WARD STREET
WASHINGTON STREET TO ZION STREET
CURB PROFILE
HOR. SCALE 1"=20'
VER SCALE 1"=2'
Stations Measured on Center Line & on Slope
Day BooK No. 08704 NotebooK 759

City of Hartford
Department of Engineering
January 1945

THIS PROFILE TO BE USED WHEN "WARD ST." is PAVED AND WIDENED TO A 36' Roadway

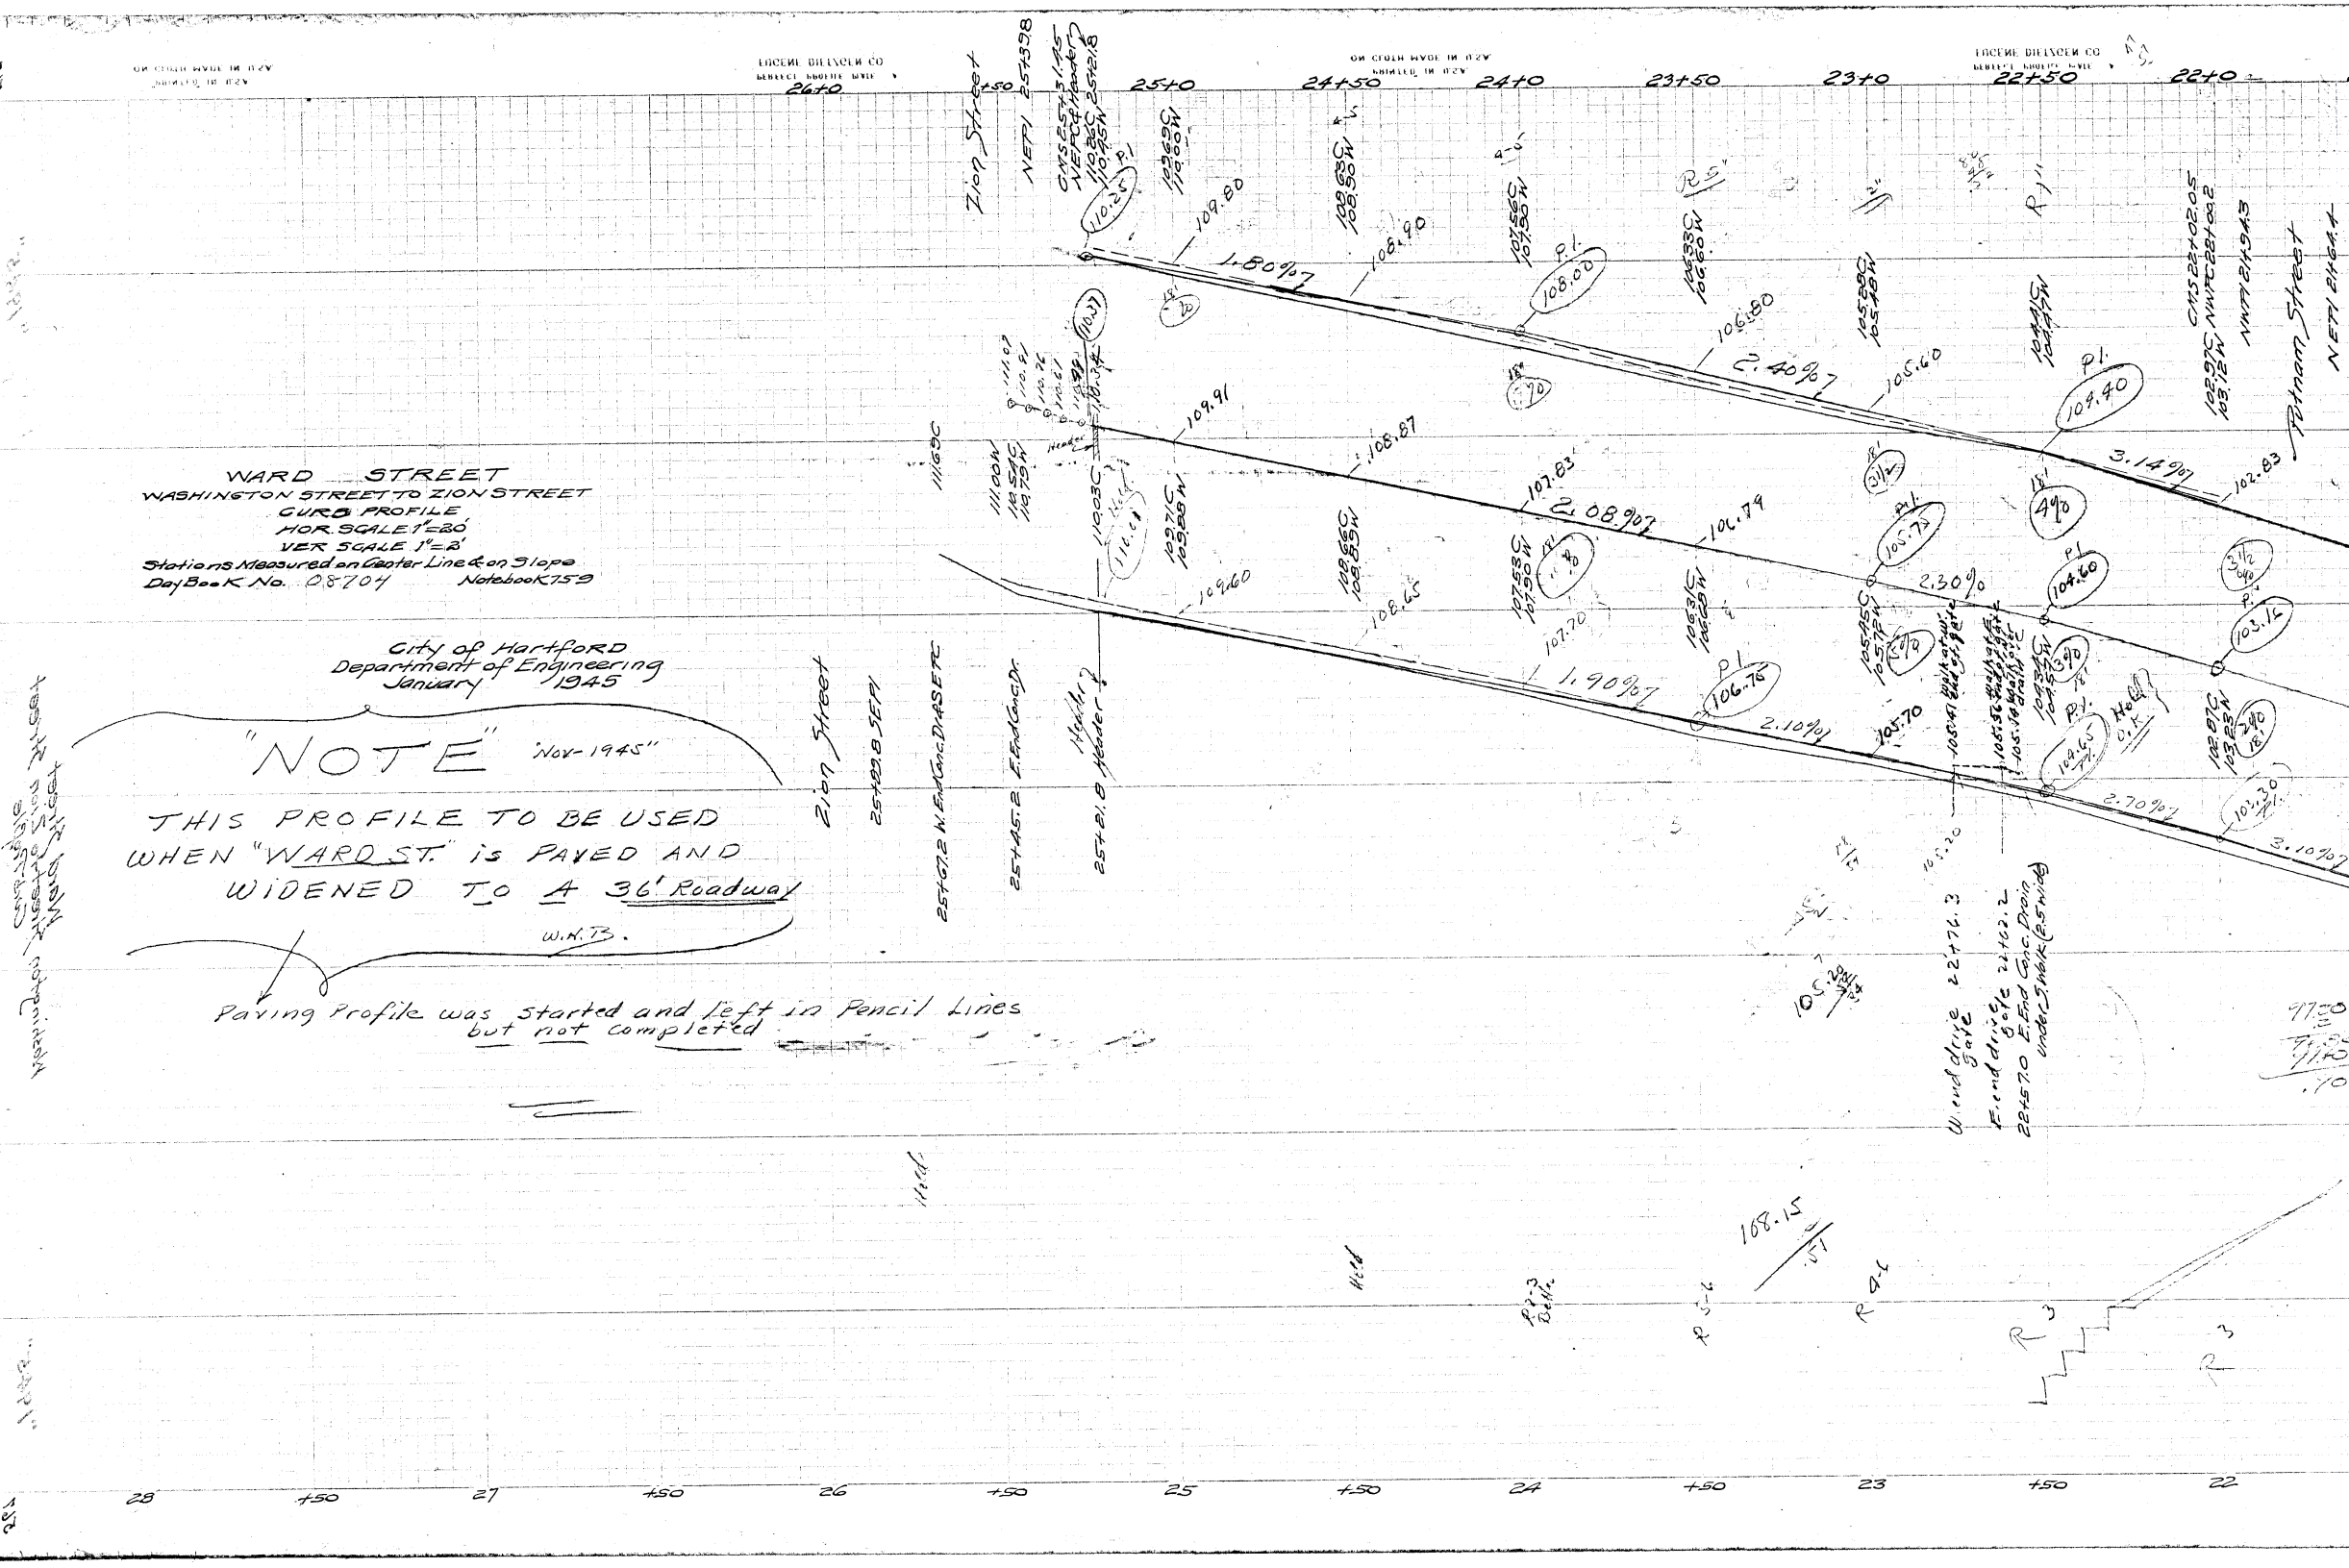
Paving Profile was started and left in Pencil Lines but not completed

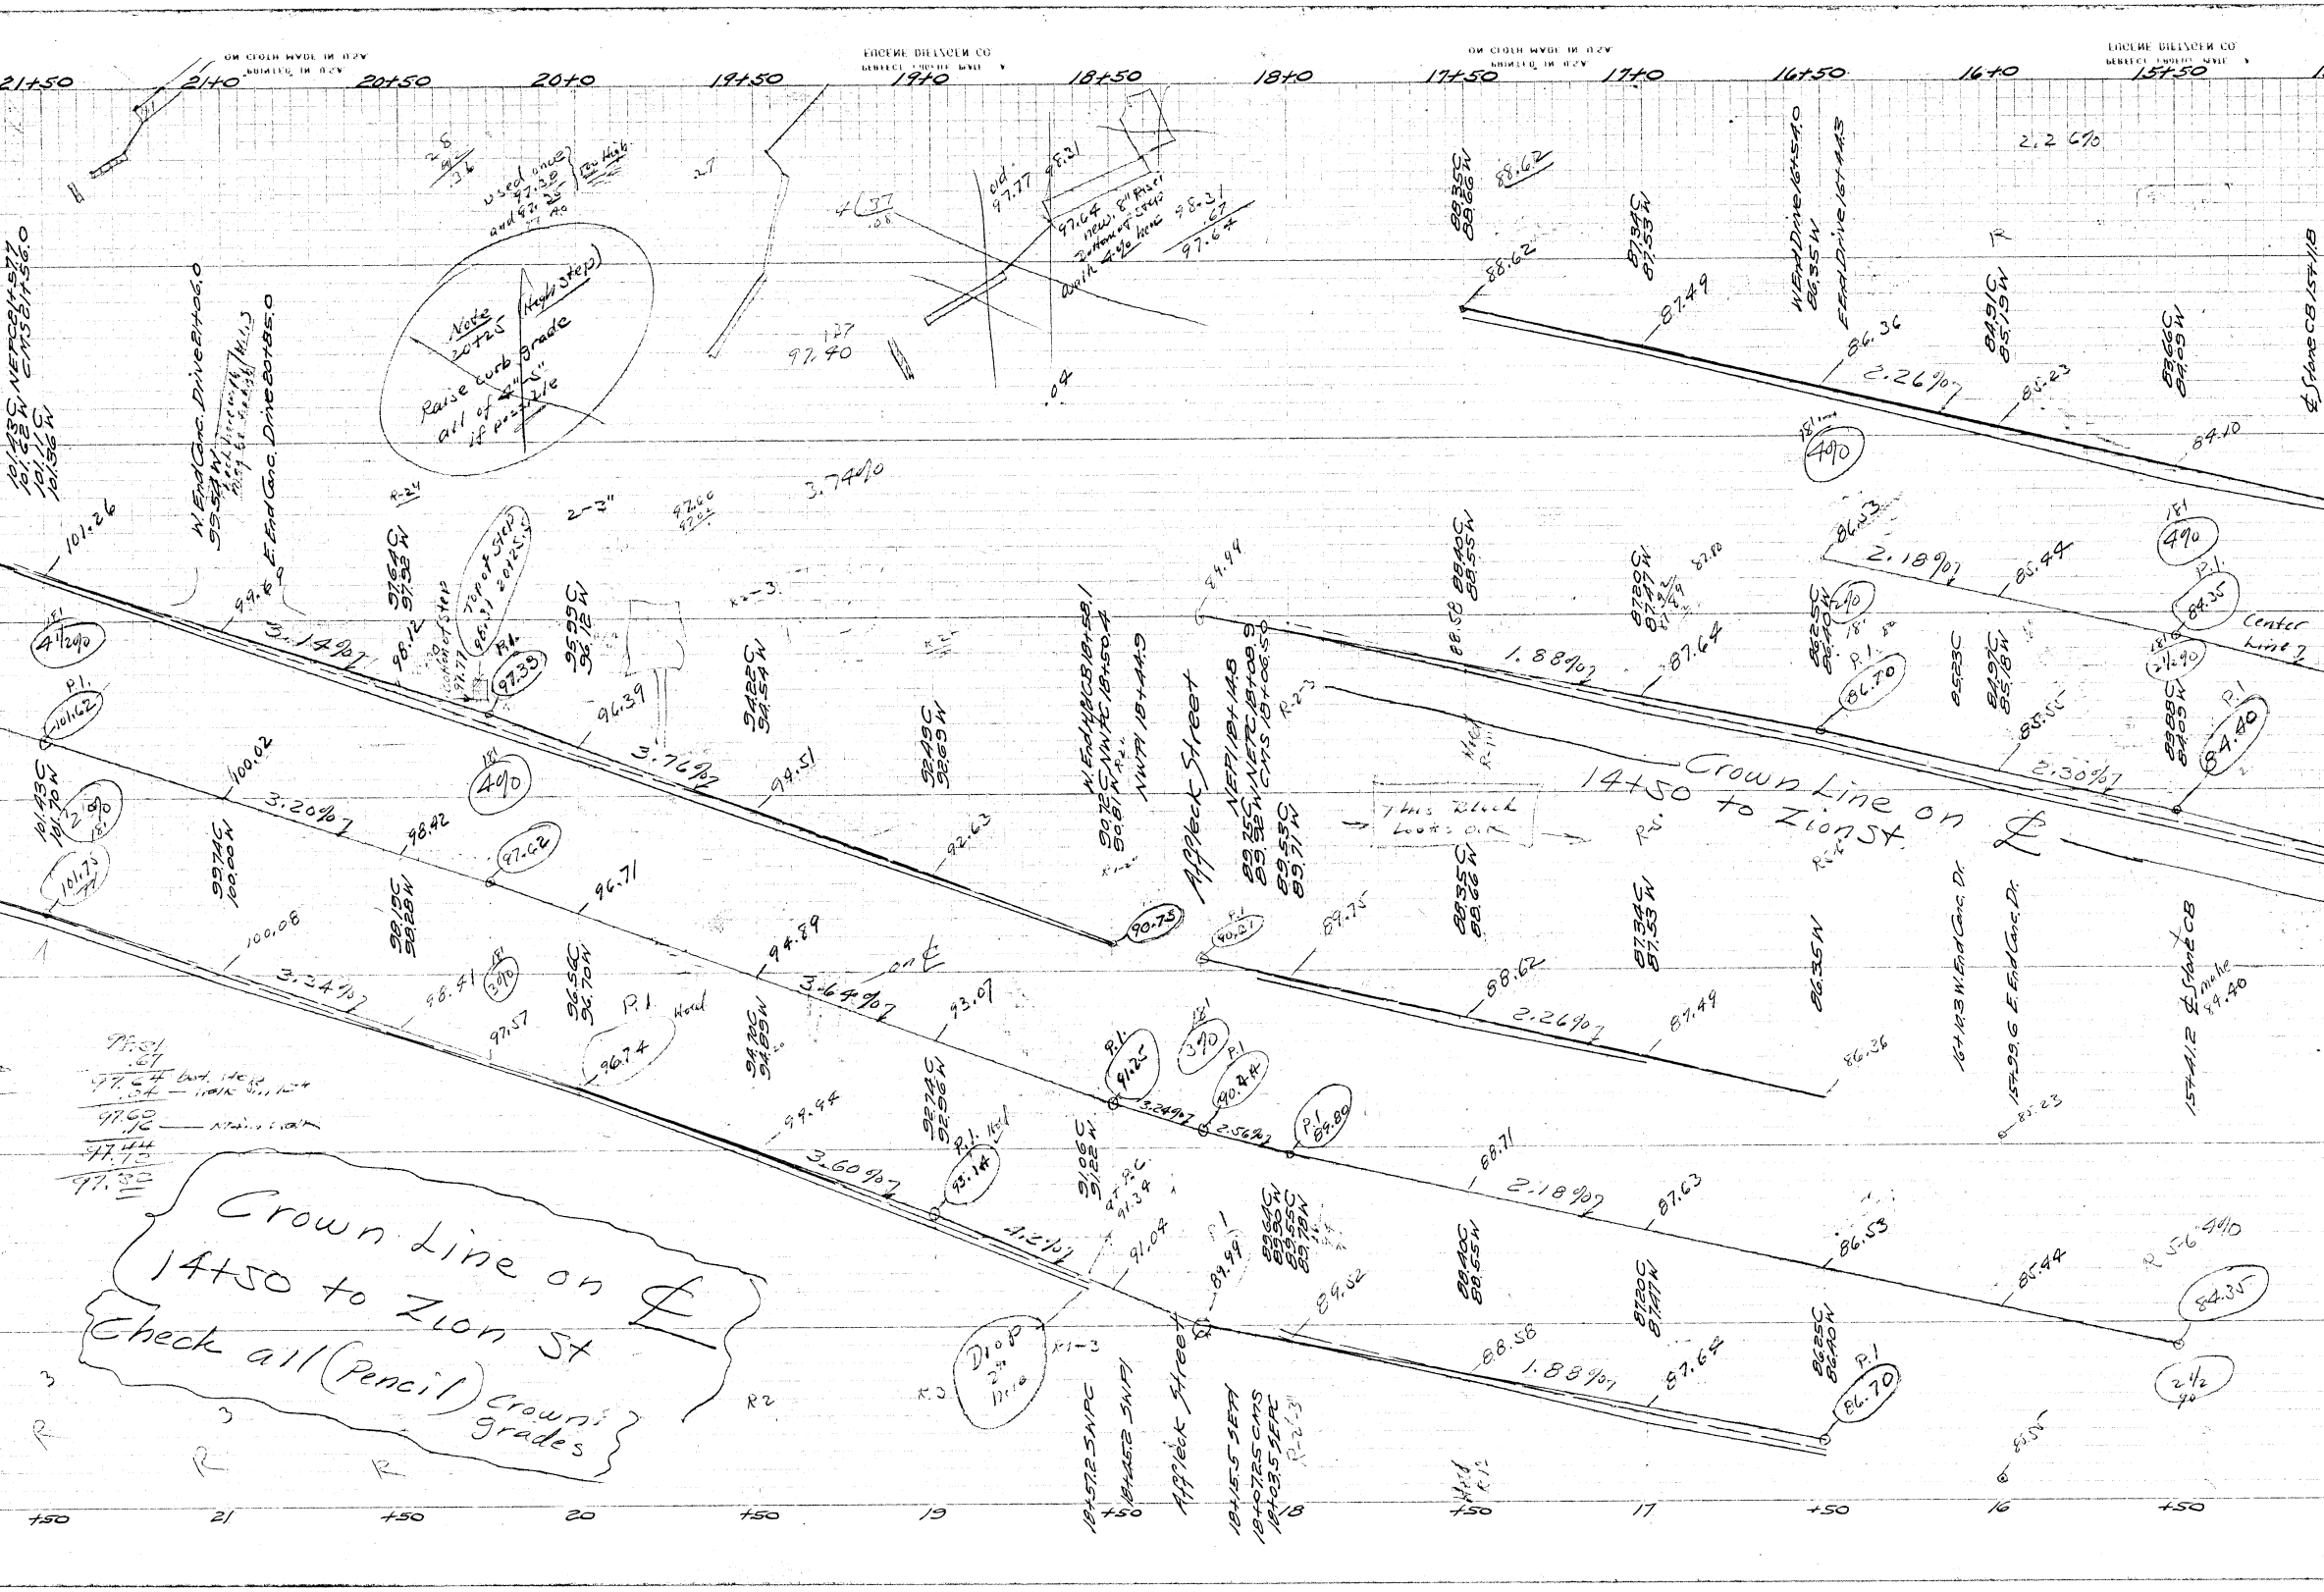
21+50
21+0
20+50
20+0
19+50
19+0
18+50
18+0
17+50
17+0
16+50
16+0
15+50
Note 20+25 (High step)
Raise curb grade all of 4"-5" if possible
used once 97.38 and 97.35
Too High

Check all (Pencil) Crown grades

97.81
.67
97.64 bot. step
.34 — walk
97.60
.16 — Main Walk
97.44
97.30

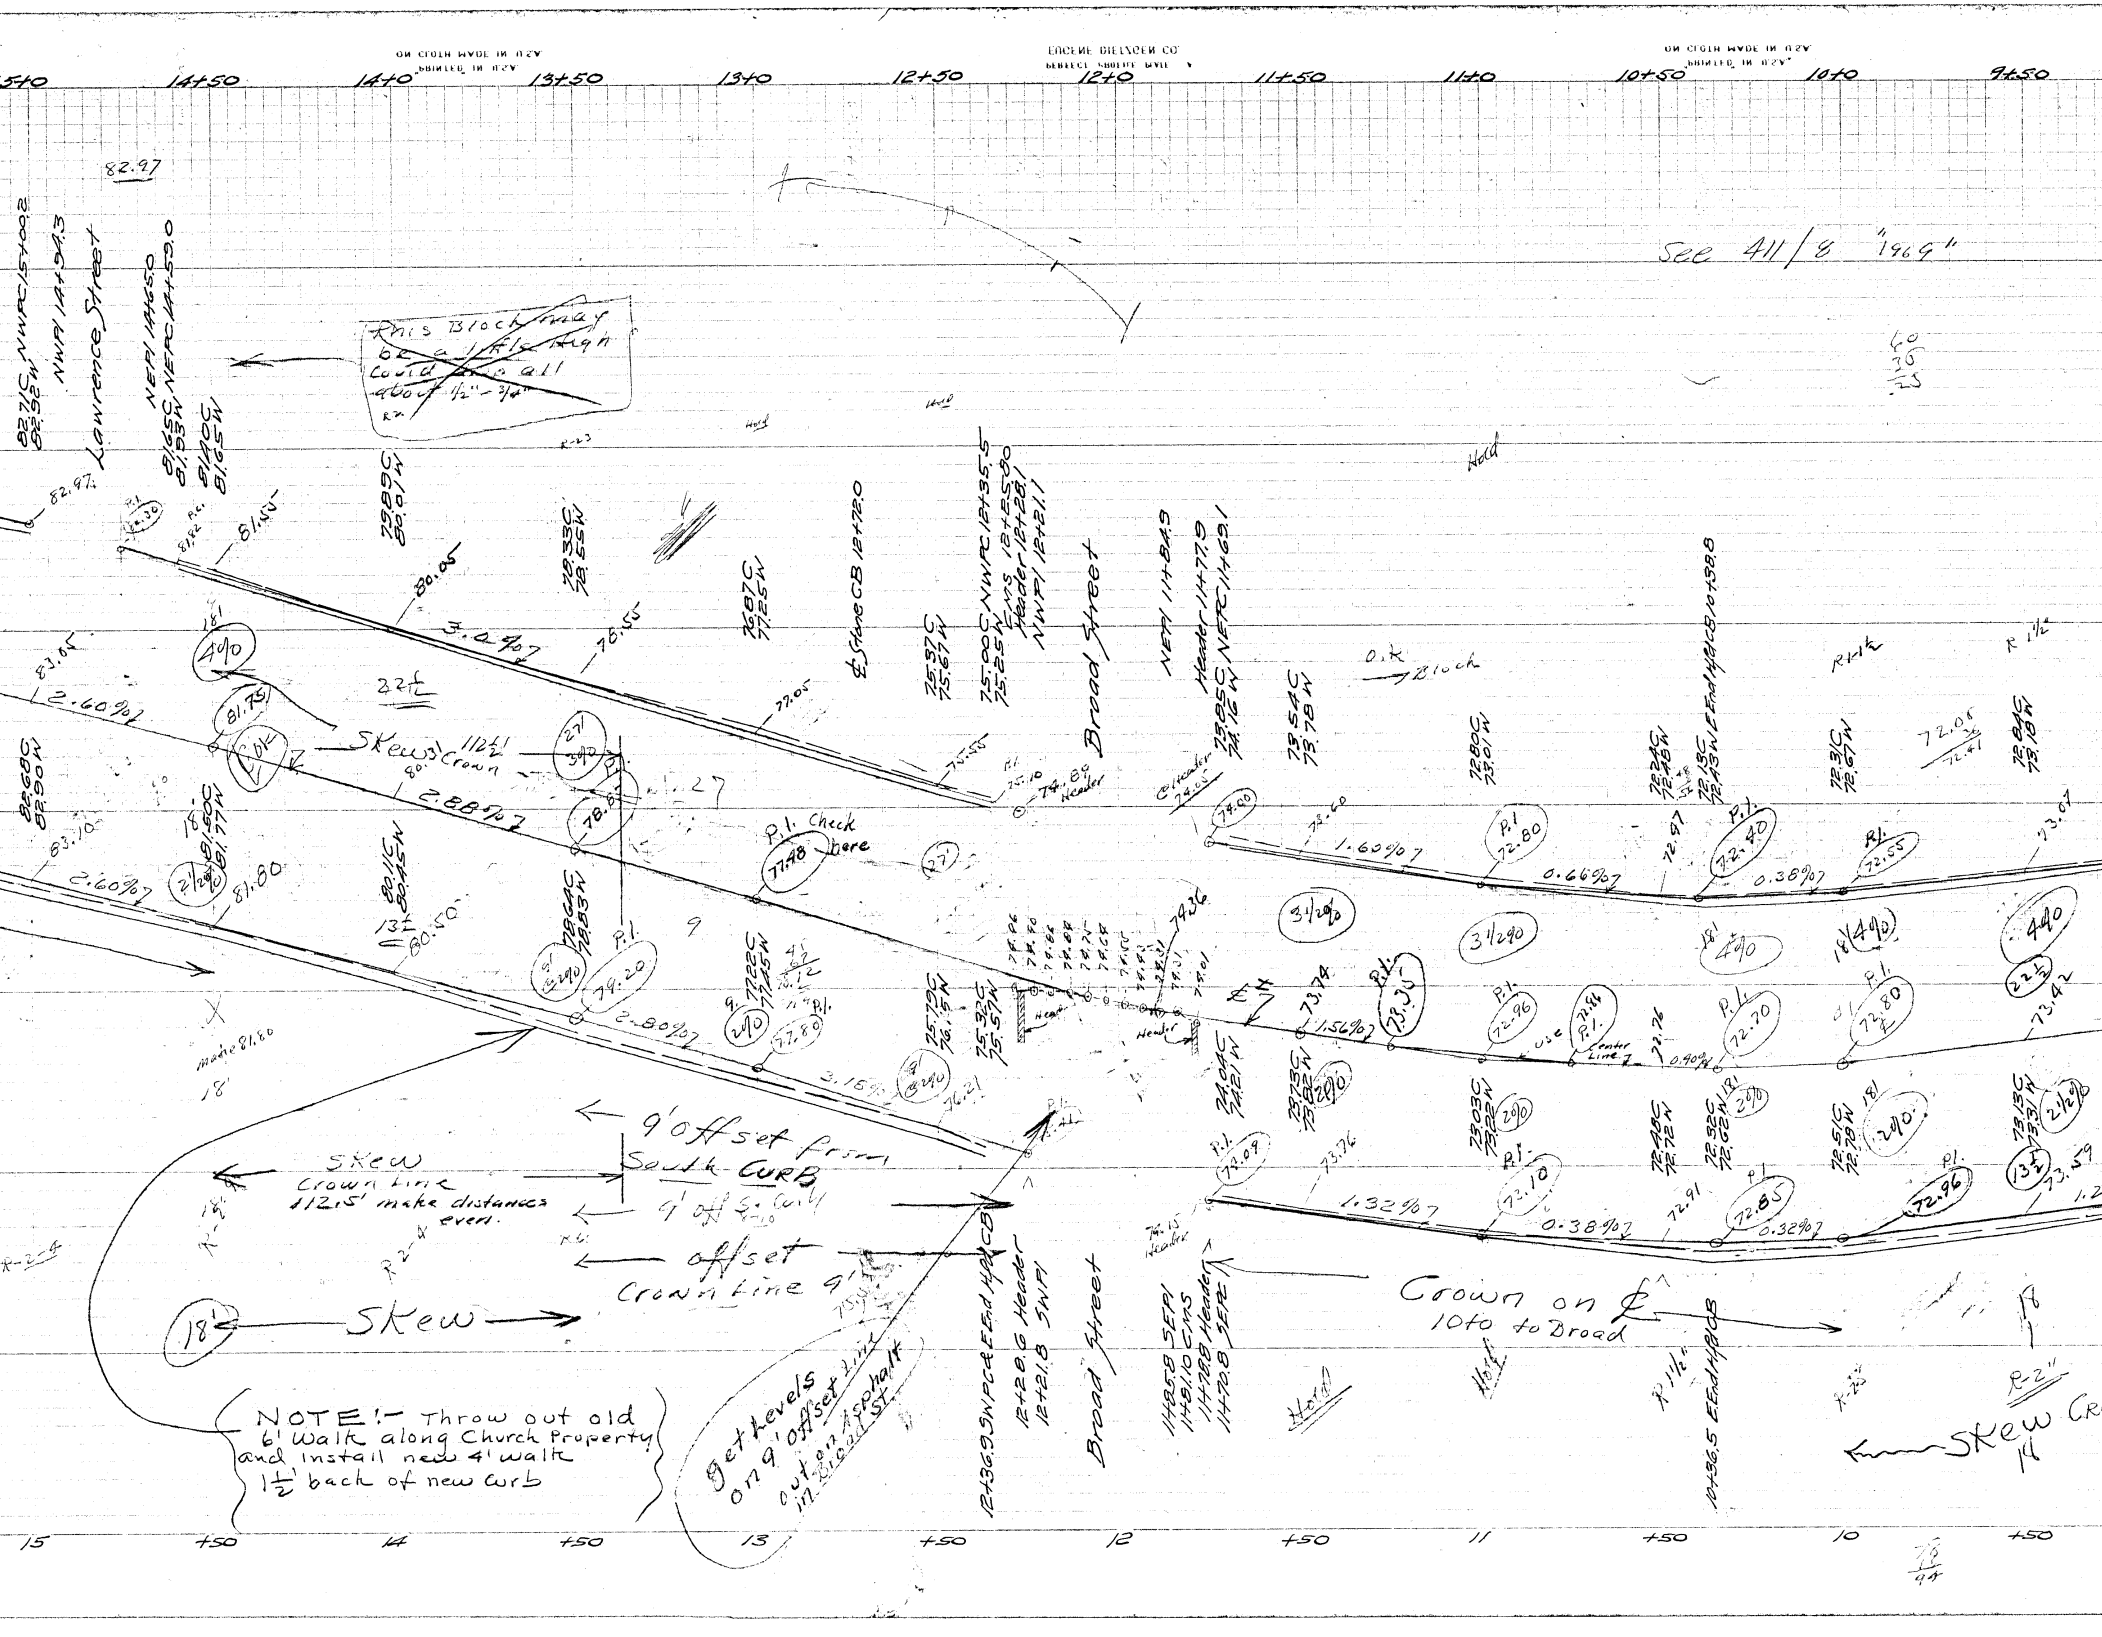
82.92W
NWPI 14+94.3
Lawrence Street
NEPI 14+65.0
NEPC 14+59.0
81.65C
81.93W
81.40C
81.65W
~~This Block may be a little high could drop all about 1/2" - 3/4"~~
See 411/8 "1969"

81.75
2.60%
83.05
Skew Crown 112.5'
2.88%
3%
78.65
77.27
P.I. Check here
77.48
22'
82.68C
82.90W
83.10
2.60%
81.60C
81.77W
81.80
80.11C
80.45W
80.50
78.64C
79.83W
79.20
P.I.
77.22C

NOTE! - Throw out old 6' Walk along Church Property and install new 4' walk 1 1/2' back of new Curb

get levels on 9' offset line out on Asphalt in Broad St.
